Access Compliance Report

Public Rights-of-Way

(Curb Ramps)

Intersection ID: 8600	Main Street: NEWELL_ACRES_DR	Cross Street: NEWELL-HICKORY_GROVE_RD	Location: NW
ADA ID: EF82D4A06963	Ramp Type: Perp	Initial Pass/Fail: Fail	Overall Compliance: No
Severity Score: 46.25			
Codes/Mitigation Info/Possible Solution		Field Measurements/Component Compliance

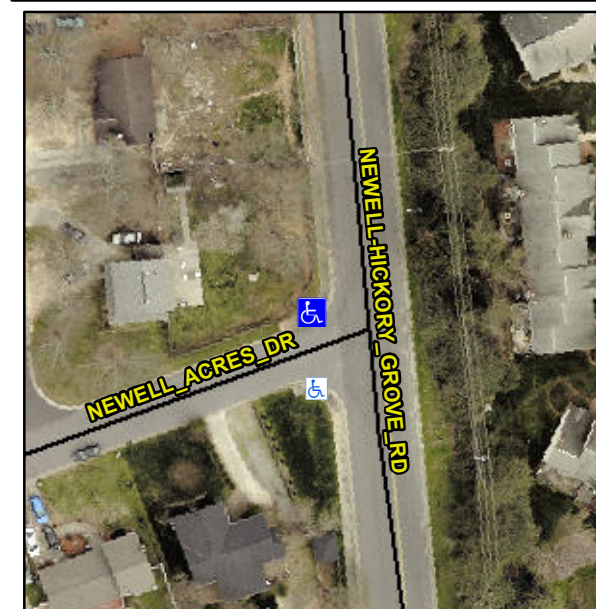
Not Found, R304.5.1, R304.2.2, R304.5.3

Compliance	Description	Data	Compliance	Description	Data
N/A	Ramp Length (in)	61.0	No	Ramp Slope (%)	9.0
No	Ramp Width (in)	40.0	No	Ramp XSlope (%)	10.2
N/A	Flare Type LT	N/A	N/A	Flare Type RT	N/A
N/A	Flare Slope LT (%)	N/A	N/A	Flare Slope RT (%)	N/A
N/A	Flare Traversable LT?	N/A	N/A	Flare Traversable RT?	N/A
N/A	Landing Length (in)	N/A	N/A	DWS Provided?	N/A
N/A	Landing Width (in)	N/A	N/A	DWS Contrast?	N/A
N/A	Landing Slope (%)	N/A	N/A	DWS Length (in)	N/A
N/A	Landing X Slope (%)	N/A	N/A	DWS Full Width?	N/A
N/A	Landing Curb? (Y/N)	N/A	N/A	DWS Offset (in)	N/A
N/A	Shared Landing?	N/A			
N/A	Gutter Ponding?	N/A	N/A	Gutter Slope (%)	N/A
N/A	Gutter Lip Ht (in)	2.0	N/A	Gutter X Slope (%)	N/A
N/A	Painted X Walk1?	No	N/A	Painted X Walk2?	N/A
	X Walk 1 Direction	To S		X Walk 2 Direction	N/A
N/A	X Walk 1 Width (in)	N/A	N/A	X Walk 2 Width (in)	N/A
	X Walk 1 Slope (%)	1.3		X Walk 2 Slope (%)	N/A
	X Walk 1 X Slope (%)	4.7		X Walk 2 X Slope (%)	N/A

Remove & Replace Entire Ramp.
